# Engineering Note

Title:	EPROM Jumper settings for HC-IV Operator Terminal
Document reference (DRC):	EN0018 issue 1
Last updated:	4/3/97
Products affected:	HC-IV operator terminals up to revision C
Author:	R.E.B. Holland
Search keywords:	HC-IV, EPROM, Jumper,
Summary:	Describes jumper changes which may be required when upgrading firmware in a Hydro-Control IV operator terminal revision C or below.

Setting jumper position for HC-IV EPROM version 2.30 onwards

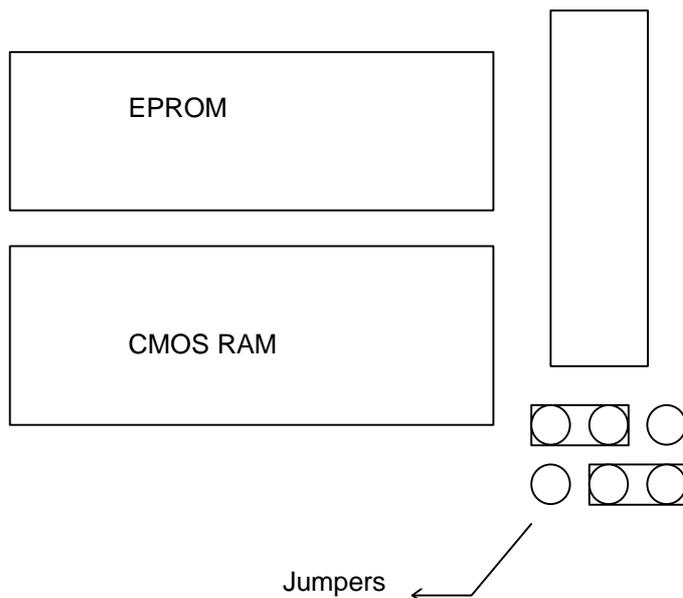
Hydro-Control IV firmware version 2.30 requires a larger EPROM than previous versions. If you are upgrading from an earlier version, you will need to re-position jumpers on the circuit board to accommodate the new EPROM.

This change only affects operator terminal revision letters C or earlier, since later models were always shipped with firmware revisions higher than 2.30.

The required position is shown in the diagram below.
